The Commission has issued the enclosed Amendments Nos. 102, 102, and 99 to Licenses Nos. DPR-38, DPR-47 and DPR-55 for the Oconee Nuclear Station, Units Nos. 1, 2 and 3. These amendments consist of changes to the Station's common Technical Specifications (TSs) in response to your applications dated September 8 and September 10, 1981.

These amendments revise the TSs to reflect current calculated string errors used in the determination of Reactor Protective System setpoints and upgrade the format of the Operational Safety Instrumentation Table.

AMENDMENT TO FACILITY OPERATING LICENSE

SAFETY EVALUATION BY THE OFFICE OF NUCLEAR REACTOR REGULATION
SUPPORTING AMENDMENT NO. 102 TO FACILITY OPERATING LICENSE NO. DPR-38
AMENDMENT NO. 102 TO FACILITY OPERATING LICENSE NO. DPR-47
AMENDMENT NO. 99 TO FACILITY OPERATING LICENSE NO. DPR-55

Figure 2.3-1C

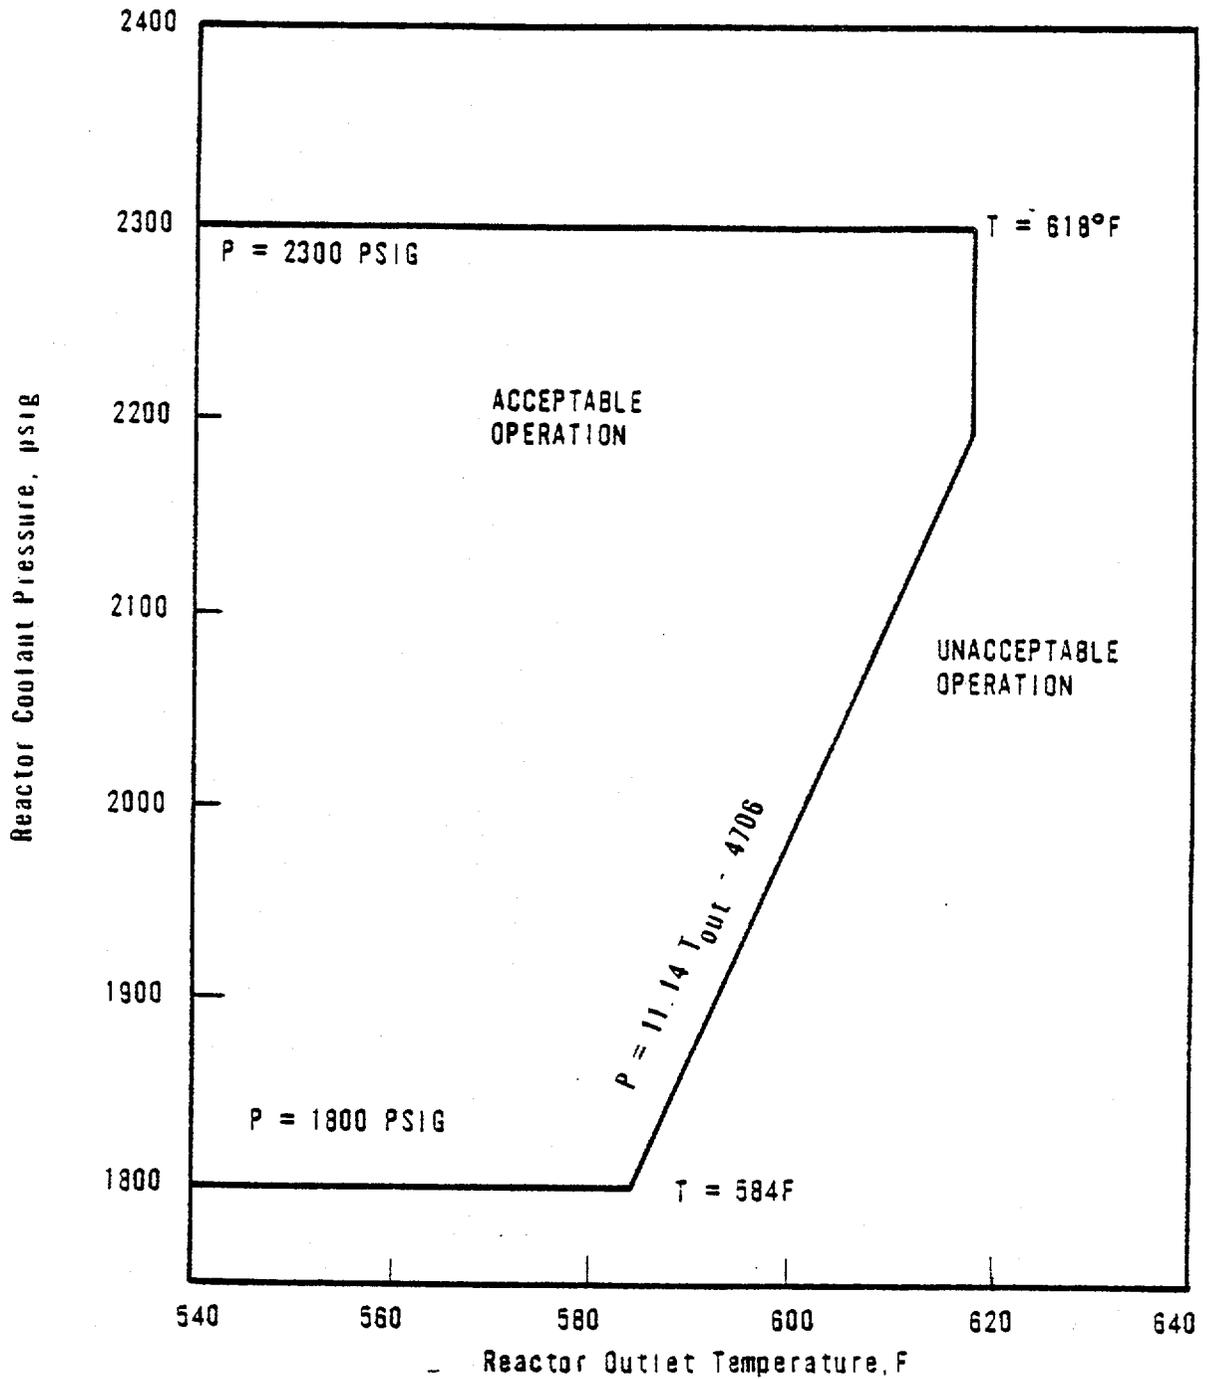
The changes to Section 2.1 and the Protective System Maximum Allowable Setpoints in Section 2.3 were calculated for Oconee Unit 3 and apply only to that Unit. Similar changes will be incorporated in the reload applications for Oconee Units 1 and 2.
